Docket Item #12  
DEVELOPMENT SPECIAL USE PERMIT #2003-0006  
MAURY SCHOOL ADDITION

Planning Commission Meeting  
April 6, 2004

**ISSUE:** Consideration of a request for a development special use permit, with site plan, for renovations and expansion of Maury Elementary School.

**LOCATION:** 600 Russell Road

*Second-story Option*

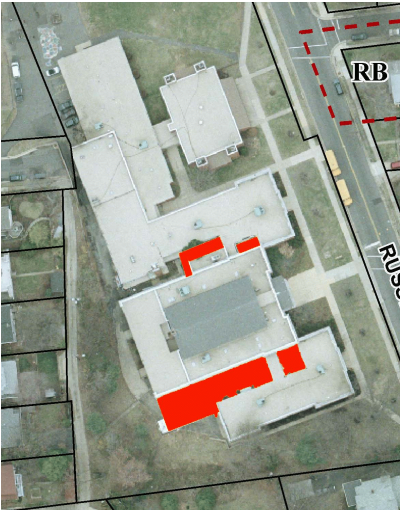
The applicant considered construction of a second story addition over the north portion of the building because that option would not increase impervious surface on the site and would minimally disrupt school operations during construction. However, this option would have created new classrooms that would be physically separated from the majority of the school space, exacerbating internal circulation problems that the school intends to improve with construction of the proposed plan. Staff was also concerned about the potential negative impacts that a second story addition would have on the surrounding single-family residences. Therefore, the applicant, the City and the community agreed that a one story addition, located in a way to minimize its impact on the community and open space, was the most viable option.
